INDESIT company

Model type:
WDS105TR

Commercial code:
F028001

FIG. 1

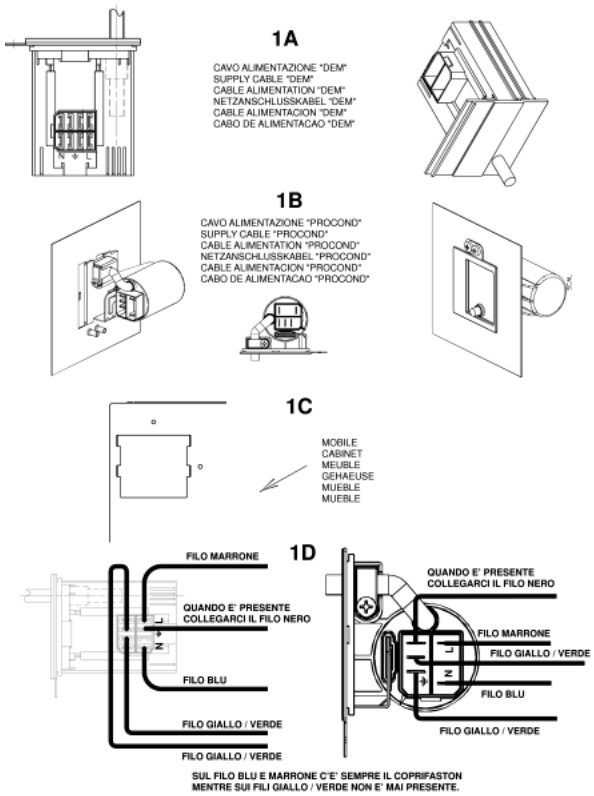
n1040276: Power supply cable + integrally moulded filter.

All appliances produced in the Comunanza (from serial no. 21008.0001), Teverola (from serial no. 21111.0001) and Brembate (from serial no. 21119.0001) factories have been equipped with power supply cables with integrally moulded filter (see fig.1 - 1A and 1B) and new units having a specific opening at the back for fixing the new cables (see fig. 1 - 1C).
The new units, together with the new cables, can be used in place of the premodification ones, by connecting the wiring to the cable, as shown in figure 1 - 1D.
The codes of the new units and of those replaced (ESI - table n1040276fig02), which will be managed until stocks run out, are given below.

IMPORTANT: the fixing / continuity screw is a specific self-scraping screw (code 092348) that ensures earth continuity between the filter and the unit. The same screw must be refitted in order to guarantee machine conformity.

The premodification wirings, are also managed for modified products by making the connection to the terminal block of the new cable as shown in fig. 1 - 1D.
The wiring diagrams given in the Documentation remain unchanged.

The new power supply cables are:
Code 091632 - Power supply cable 3x1 schuko 1.5m+capacitance filter;
Code 091633 - Power supply cable 3x1 schuko 1.5m+inductive filter;
Code 091634 - Power supply cable UK 3x1 l= 1950mm + inductive filter;
Code 091635 - Power supply cable UK 3x1 l=1950mm+capacitance filter;
Code 091636 - Power supply cable l=2.55m AUS+inductive filter;
Code 091641 - Power supply cable l=2550mm AG +capacitance filter;
Code 091642 - Power supply cable 1.85mt SHUKO no inductive filter;
Code 091643 - Power supply cable 3x1 (CH) 1.5m+inductive filter;
Code 091645 - Power supply cable 3450mm SOUTH AF.+capacitance filter;
Code 091690 - Power supply cable shuko l2.55m KOREA+inductive filter;
Code 091689 - Power Supply cable l=2550mm AG+inductive filter.

n1040277: Modification of pressure switch protection and tube

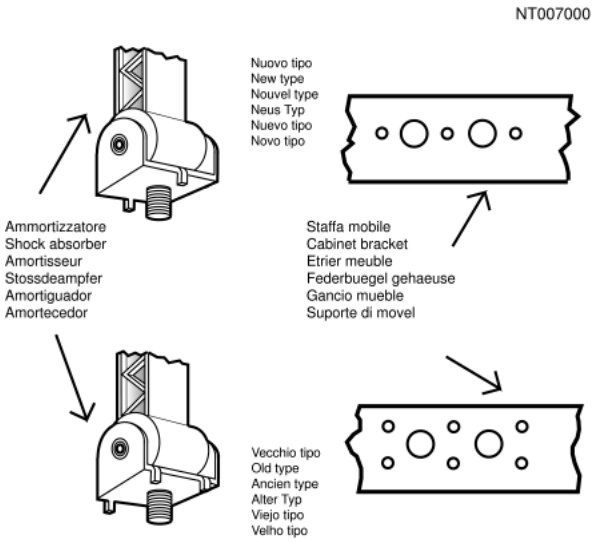
From serial no. 21104.0001, all washing machine models produced in the Brembate factory and relevant to this note have been equipped with a new pressure switch tube 041785 replacing 051552, a new pressure switch tube protection 019755 replacing

078221 and two plastic clamps replacing terminals 051541.
premodification parts will be managed until stocks run out and are interchangeable with the new ones only if used altogether.
